EASTLAKE TOWNHOUSES

3024310-EG

DESIGN REVIEW RECOMMENDATION MEETING

MEETING DATE:
MARCH 13TH, 2019
8 pm

1A Massing and Design Concept:

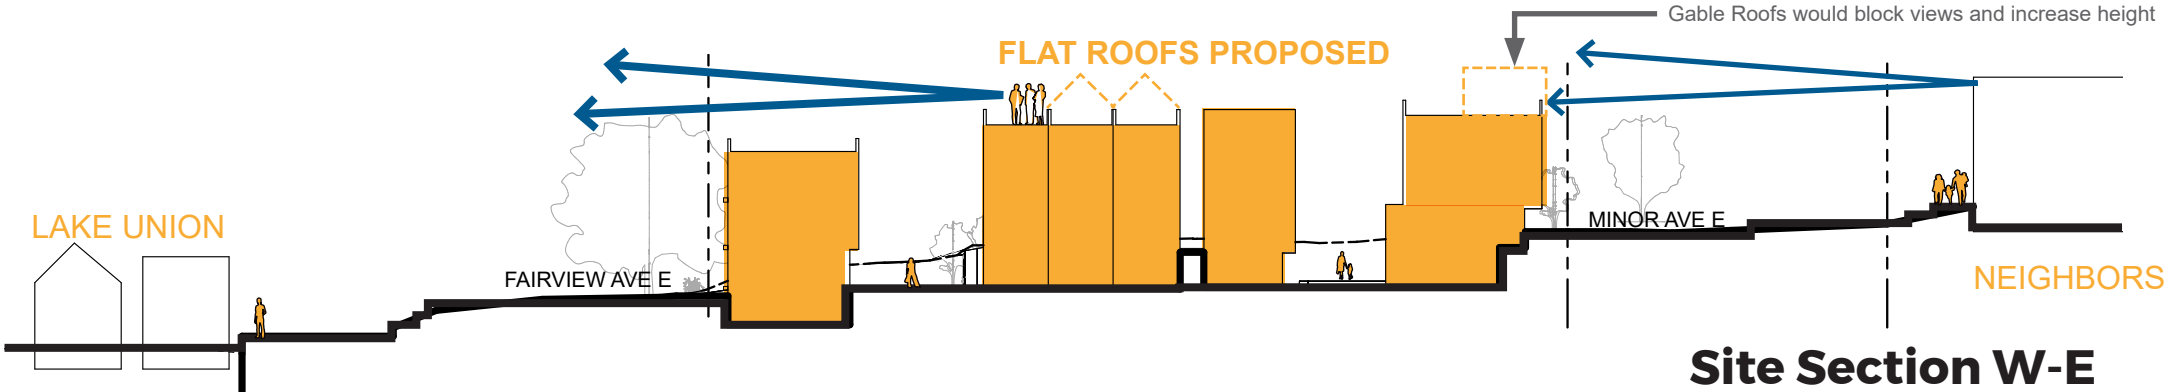
a. Acknowledging public comment, the Board discussed the use of the gable roof form as a mechanism for reducing the perceived massing of the structures and as a method for establishing character for the individual units throughout the site. The Board recommended the applicant explore areas where the gable roof can be most successful and areas where the flat roof form is more appropriate in terms of providing views to Lake Union and adding some variety to the proposal. (CS2-D Height, Bulk, and

Flat roofs were incorporated throughout the development to respond to the public comment to reduce the bulk and scale of the massing. Views from the east towards Lake Union are preserved by not providing additional height through roof penthouses or additional height through gabled roof forms. Additionally, open railings have been incorporated throughout the development to break down the scale and add texture and variety to the street edges.

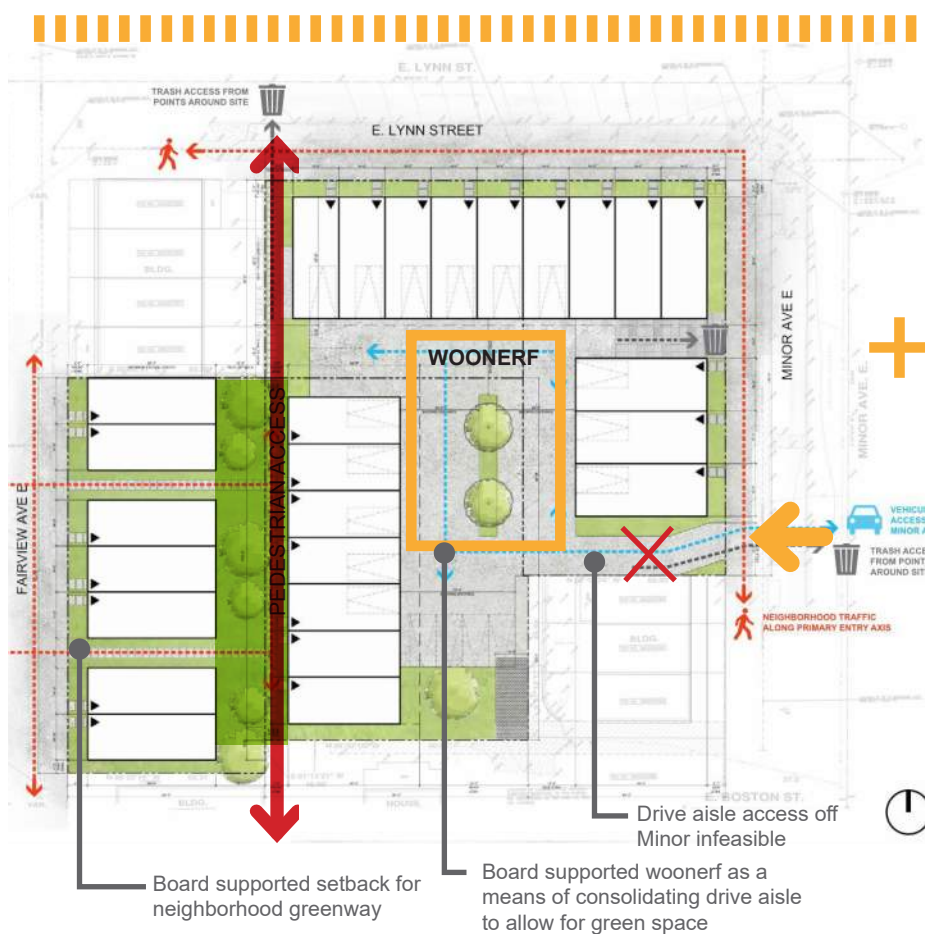
a. The Board agreed with public comment and expressed strong support for the woonerf concept, highlighting its potential to create a successful communal space that would be utilized by the residents. (PL1-A Network of Open Spaces, DC1-A-2 Gathering Places, DC1-C-3 Multiple Uses, DC4-D Trees, Landscape, and Hardscape Materials)

b. The Board agreed with public comment and encouraged the applicant to explore incorporating the view corridor present in Option Three into the design of Option Two and possibly connecting it to the proposed woonerf. This would involve providing a break in the layout of the central units. The Board expressed they would be open to a departure on Parcel C if this would assist in accommodating the view corridor and result in a stronger tie to the neighborhood. (CS2-B Adjacent Sites, Streets, and Open Spaces, PL1-B Walkways and Connections, PL1-C-1 Selecting Activity Areas)

a. Project combines the overall strengths of massing option two and massing option three to promote a sense of community and respect for adjacent sites in two dynamic ways:

First, the woonerf concept from Option 2 was maintained and developed, increasing the usability of the community active space while still allowing for vehicles to park within garage spaces at a lower level.

b. Secondly, the view corridor (Option 3) from west to east was maintained through the site to provide a visual (and physical) connection across the development.

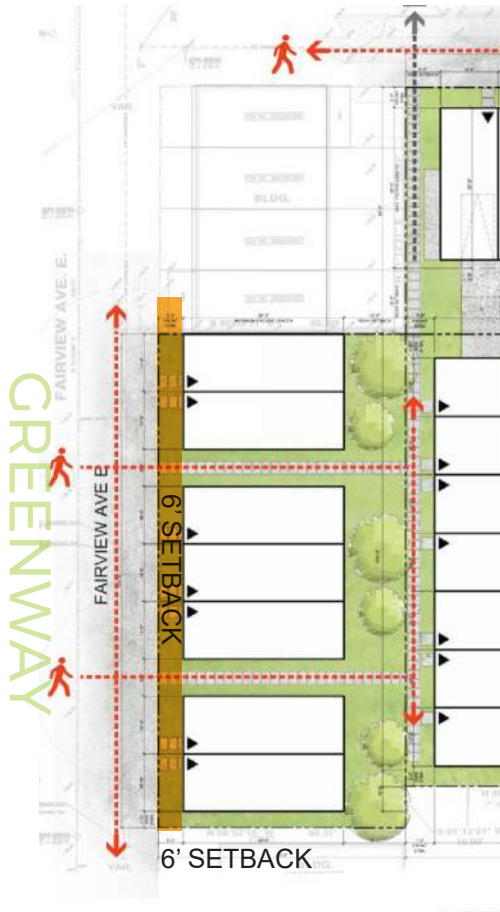
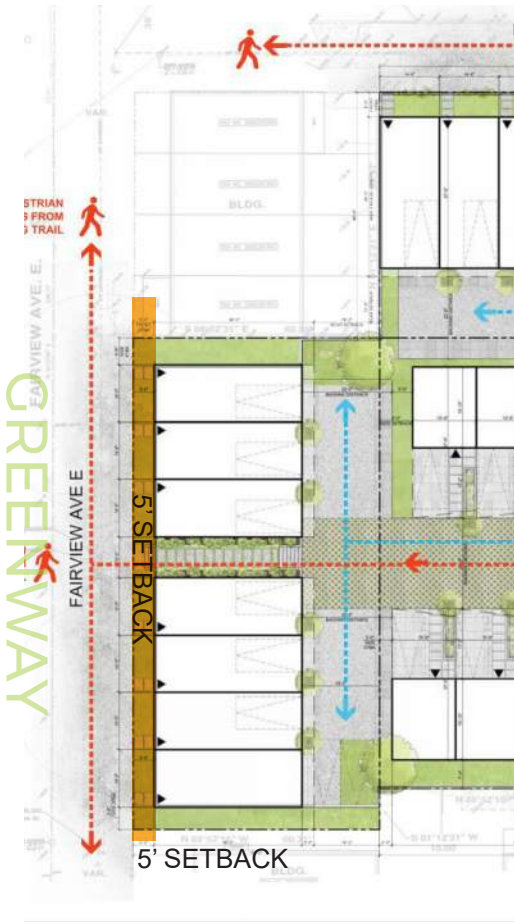
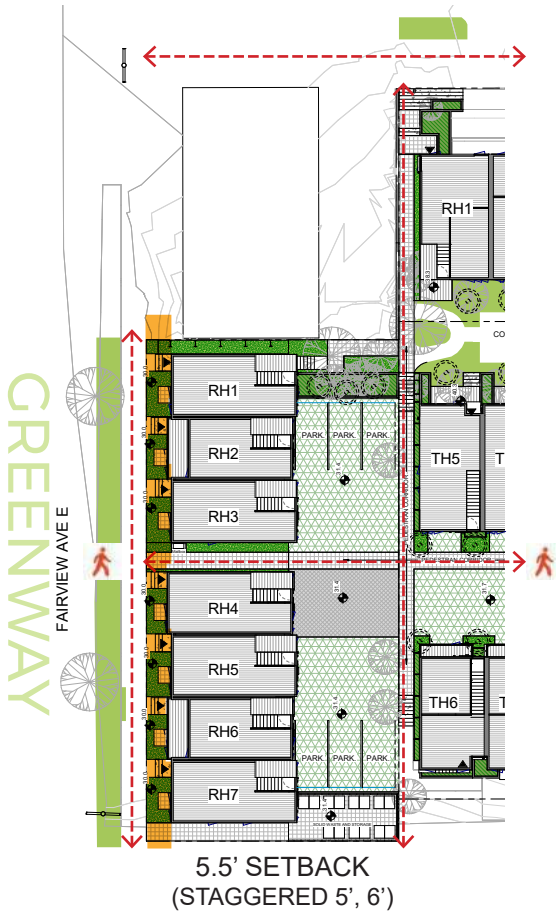
c. The Board recommended pushing the units facing Fairview Avenue East further back from the street maximizing greenspace and vegetation along the designated neighborhood greenway. (PL1-A-1 Enhancing Open Space)

c. To articulate the massing along Fairview Ave E, each unit has been pulled or pushed to define the individuality of each unit within the block. A layered landscape plan was also developed at the ground level to maximize the vegetative buffer along the sidewalk edge and further enhance the greenway along the street. Raised entry stoops welcome visitors and owners and create a sense of arrival to the units. Further recesses are carved out on the third floor to create balconies and additional eyes on the street.
